2005 BUILDING ENERGY EFFICIENCY STANDARDS

NONRESIDENTIAL
ACM MANUAL

EXPRESS TERMS – 45 DAY LANGUAGE
JULY 2003

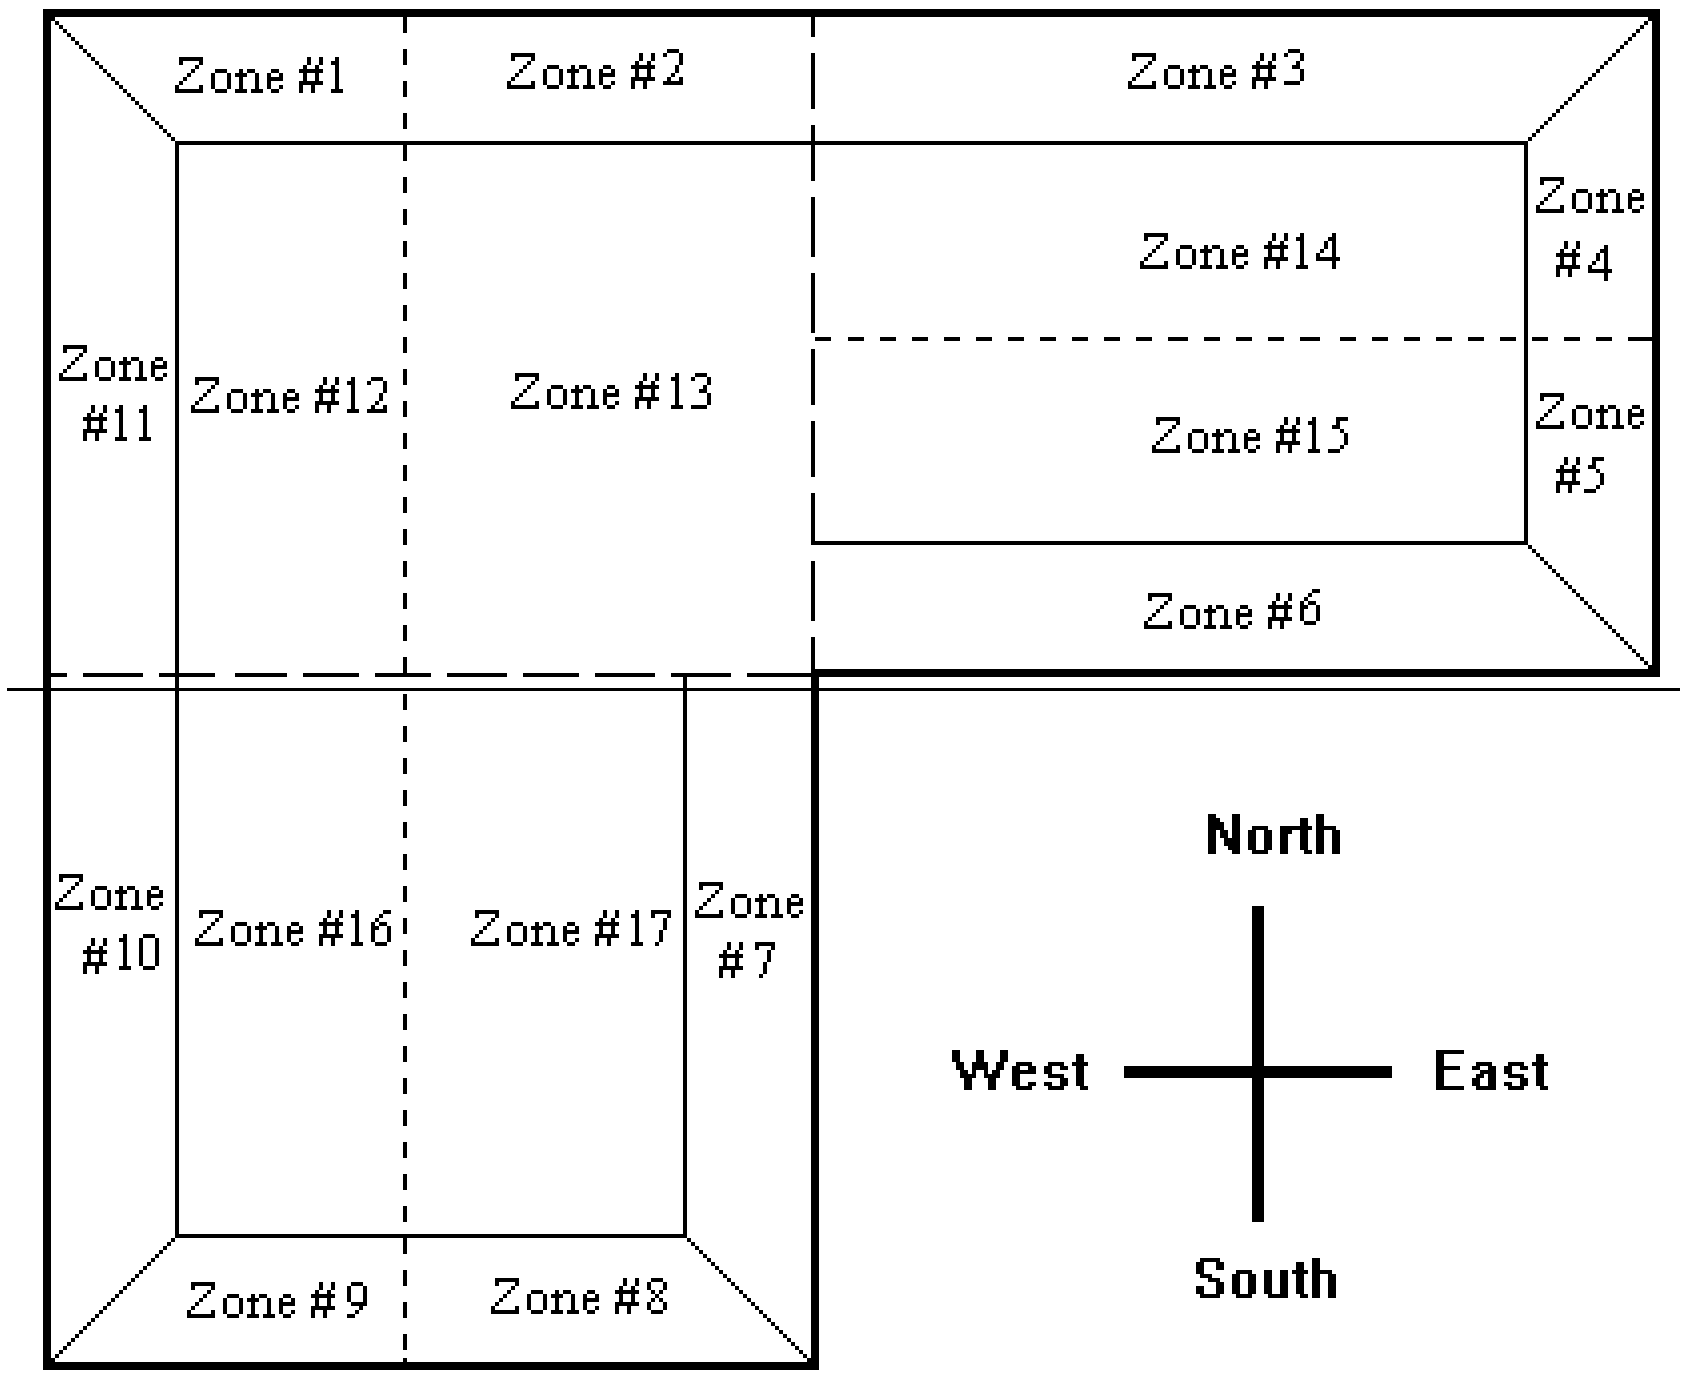
~~ACMs shall model the interface between thermal zones as air walls. ACMs shall model interior floors as input by the user, but must not allow modeling any interior walls. Walls separating conditioned spaces from indirectly conditioned spaces are considered interior walls. The heat capacity effect of interior walls and furniture shall be approximated by the program according to rules described in Section 2.2.2.13. The following example will illustrate zoning of a building with three occupancy types and six HVAC systems:~~

~~*Example:* Heavy lines show the building's footprint. Short dashed lines are boundaries separating system areas, long dashed lines are boundaries separating occupancy areas (from Table 2-1), and light solid lines show the thermal zone boundaries, which must be created by ACMs according to the rules described in Section 3.5.1.2.~~

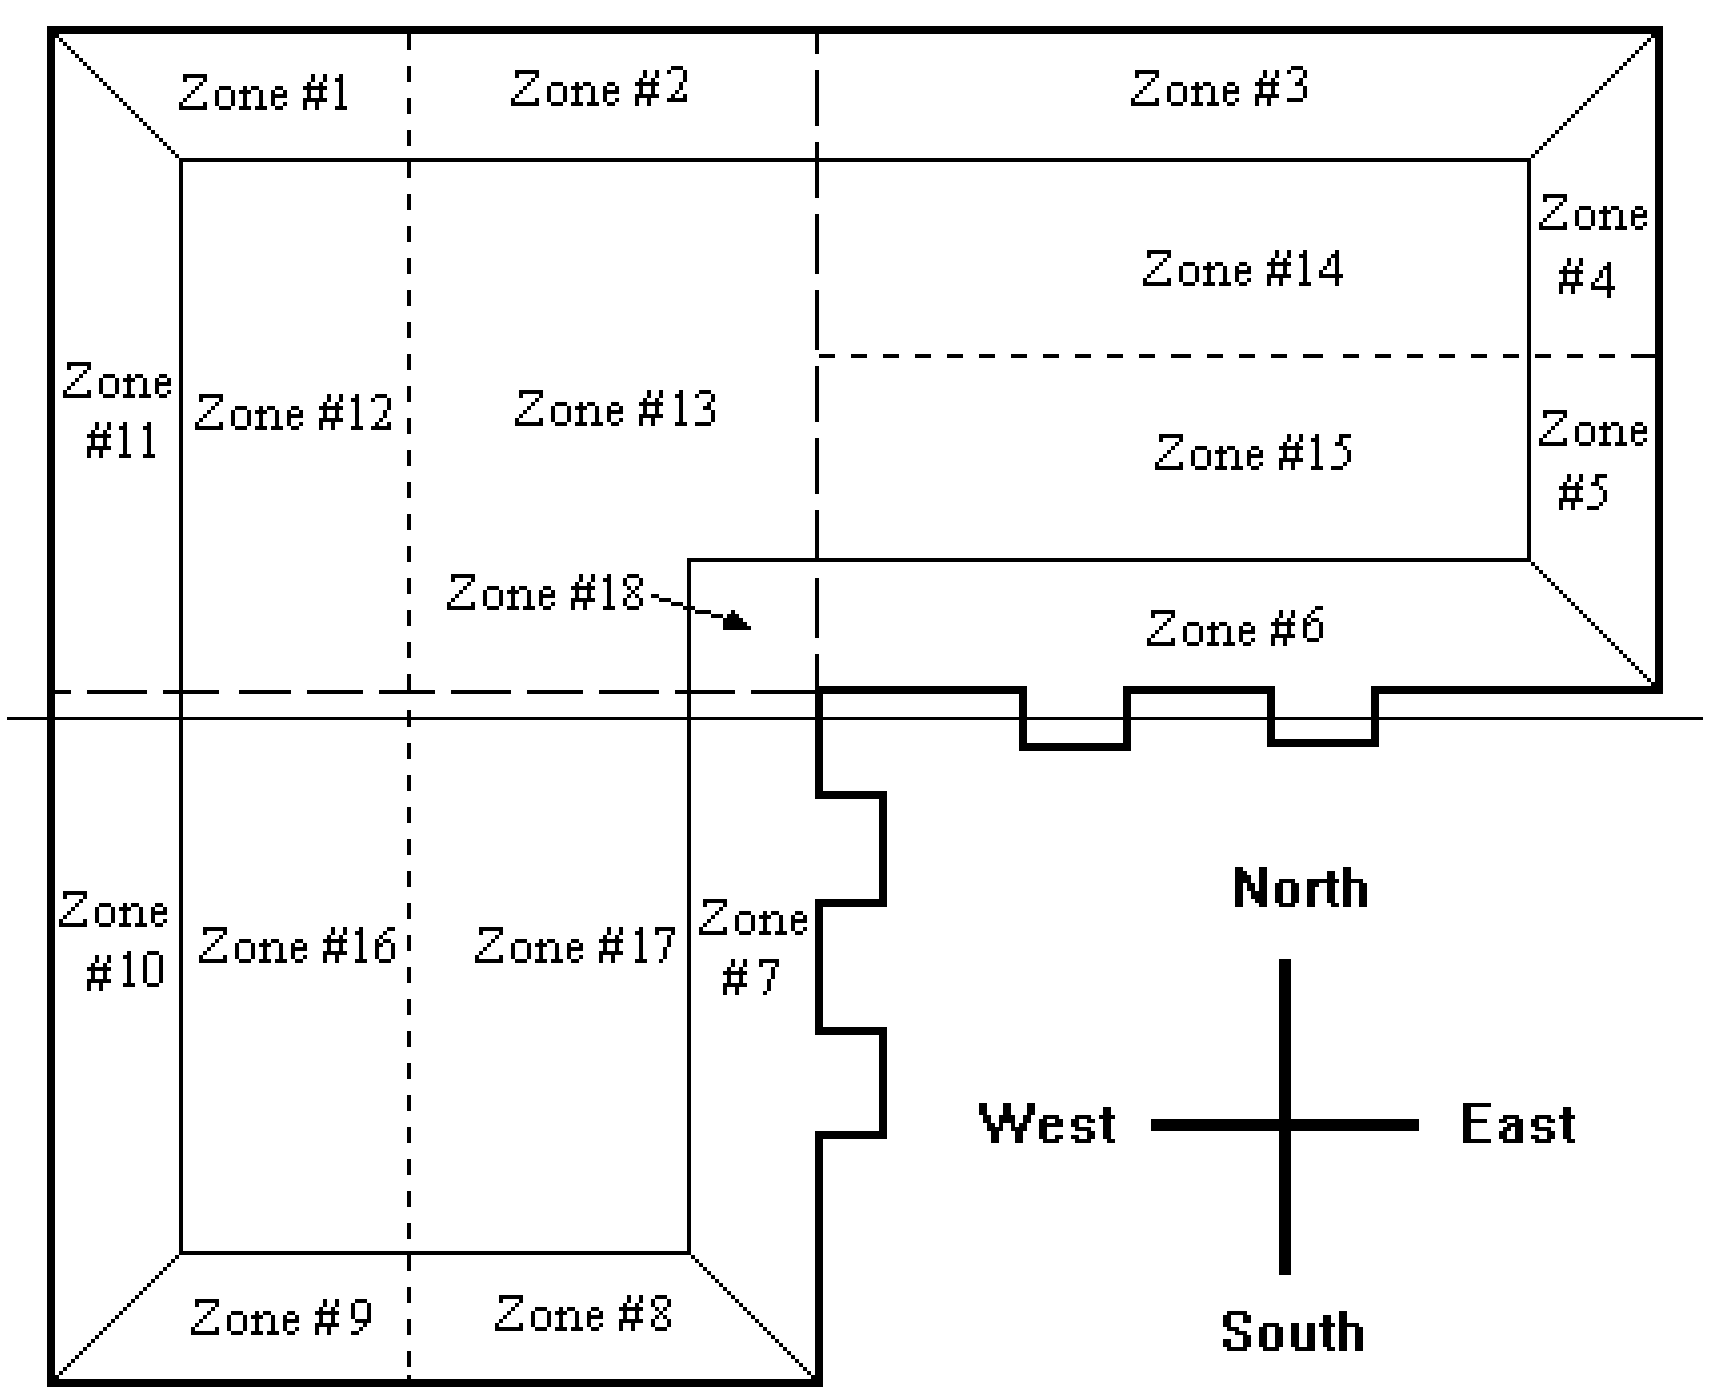
11. ~~ACMs shall model air walls between thermal zones. ACMs must not allow the user to model any interior walls. Walls separating conditioned spaces from indirectly conditioned spaces are considered interior walls. The heat capacity effect of interior walls and furniture shall be approximated by the program according to rules described in Section 2.2.2.13. ACMs shall model the actual interior floors between the thermal zones.~~

~~Example 1: Consider the following footprint. Using the above rules 1 through 6 the thermal zones will be as shown in the following drawing:~~

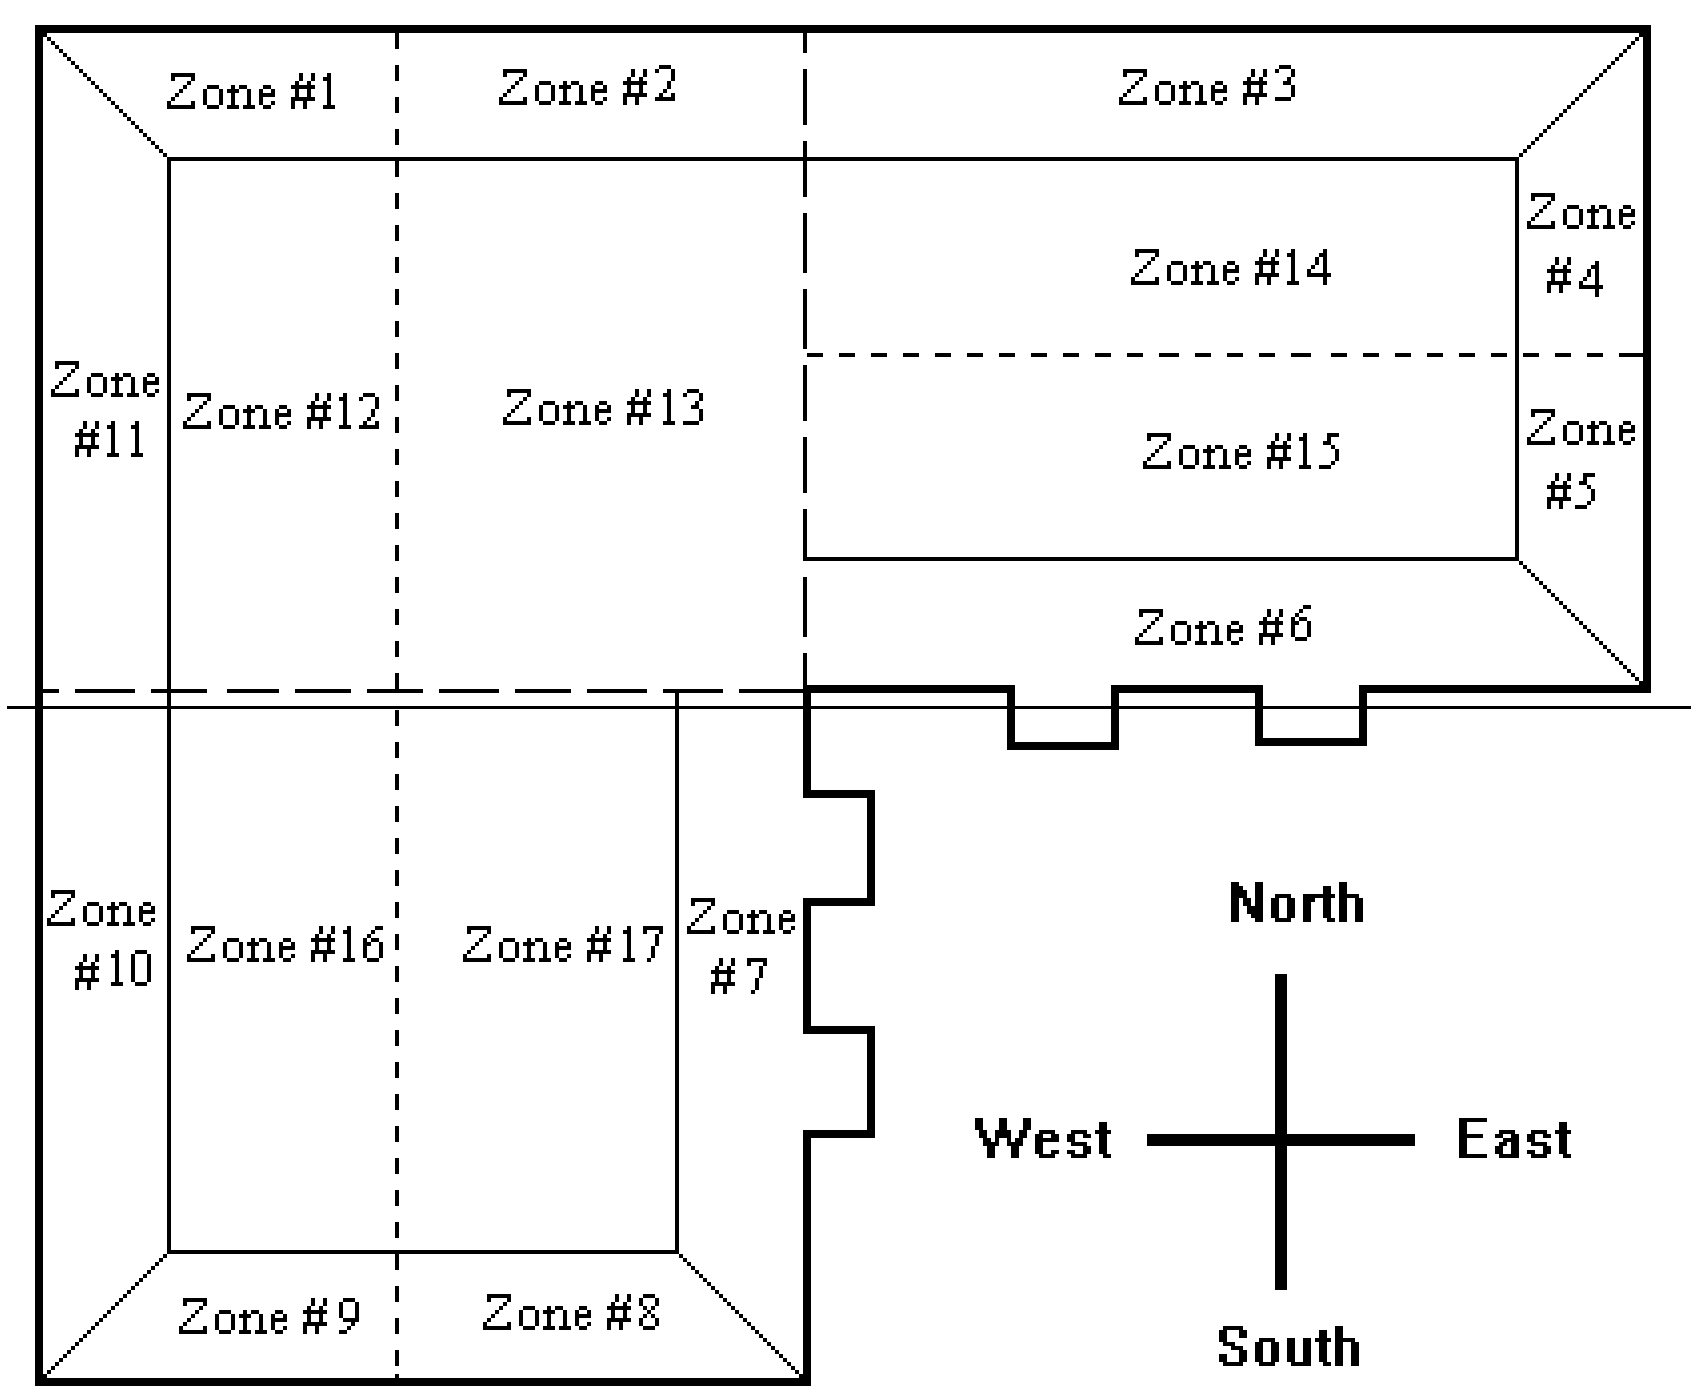
~~Zone #18 is an interior zone whose area is less than 300 ft^2. Therefore, according to rule #7 above, zone #18 is absorbed by the adjacent interior zone within the same HVAC system. The zoning will change as follows:~~

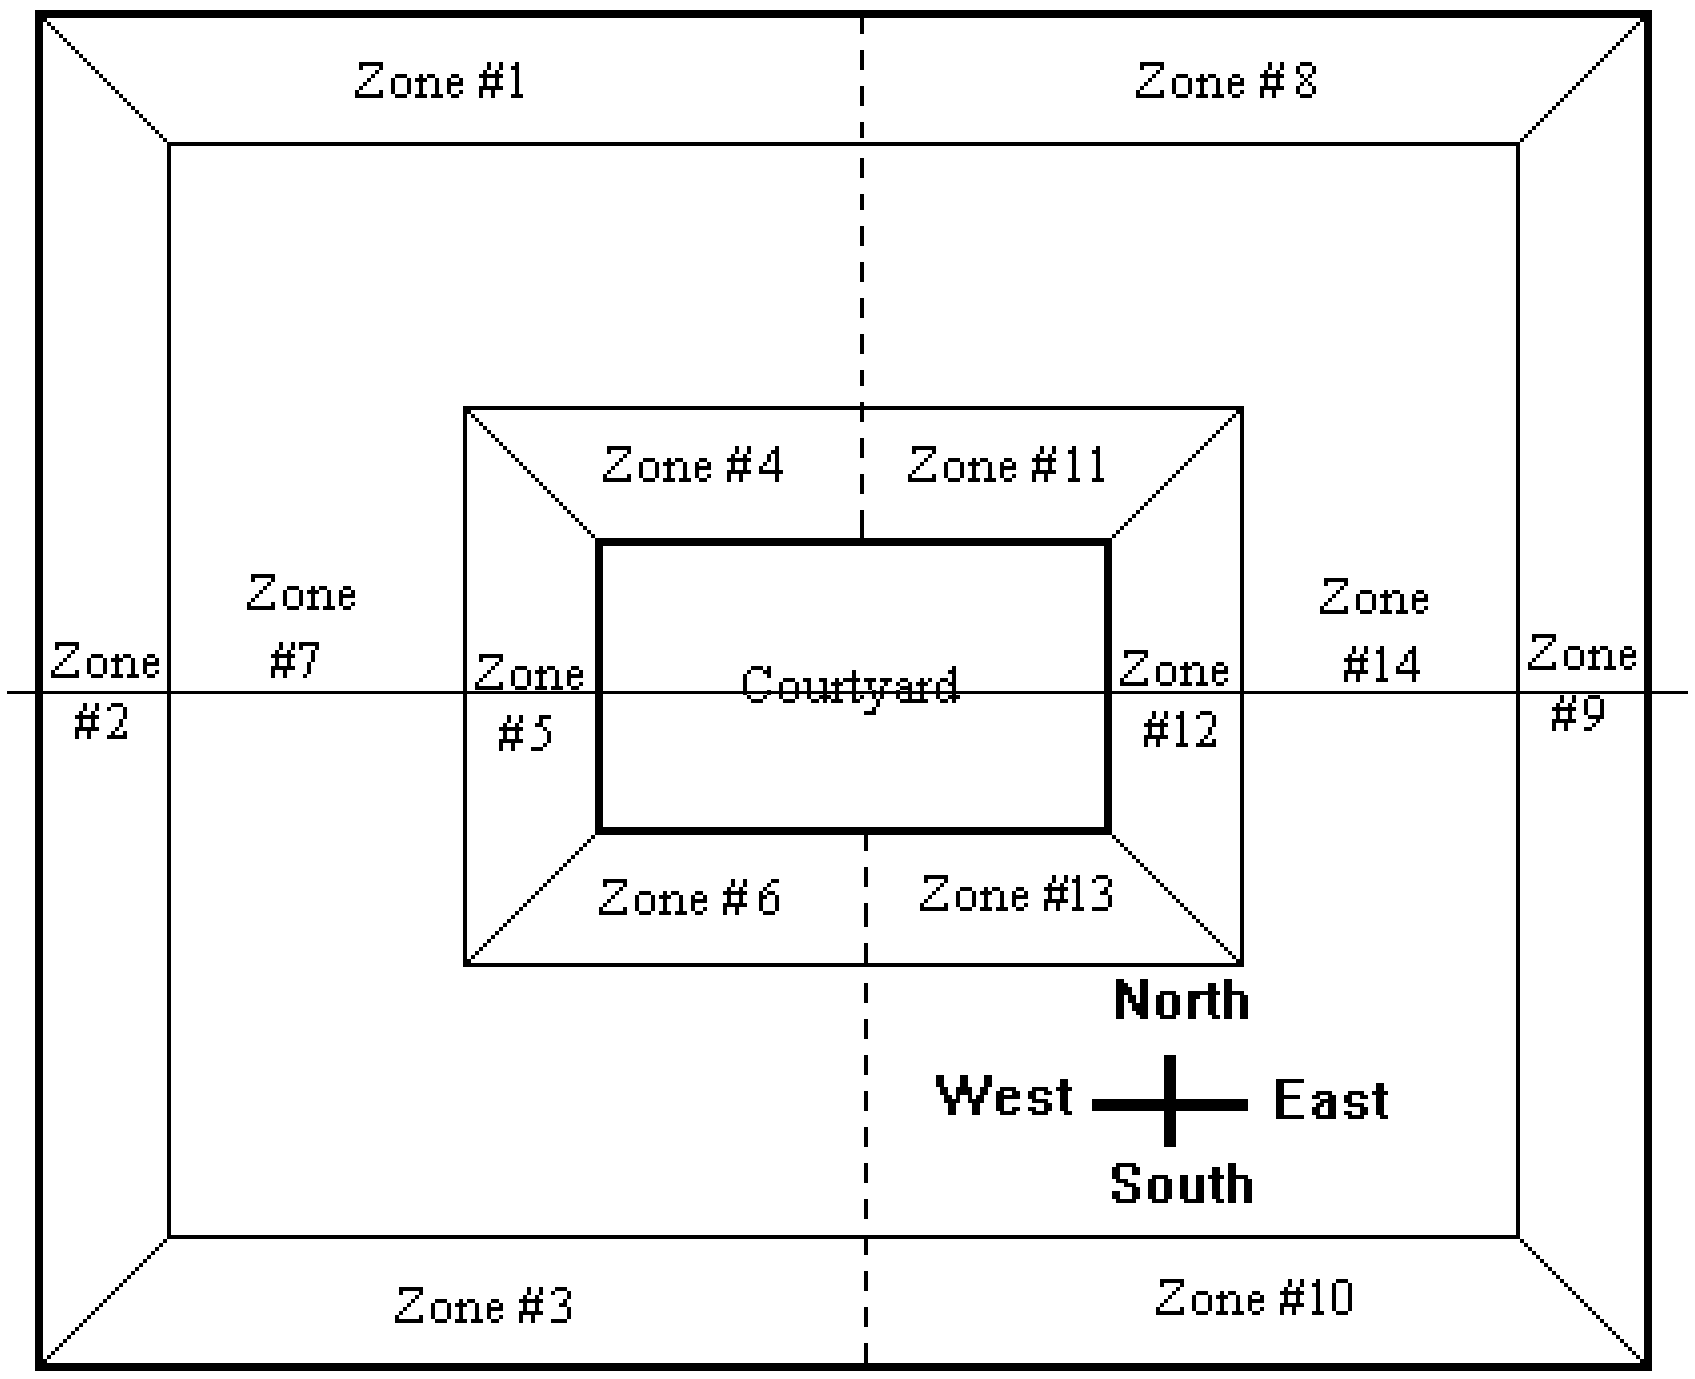
~~Example 2: Consider the following footprint. The heavy solid lines are the boundaries separating the conditioned space from the ambient air. The dashed line indicates separation between two different occupancy areas (from Table 2-1). Each occupancy area is served by a different HVAC system. The footprint includes a courtyard in the middle. The zoning will be as follows:~~
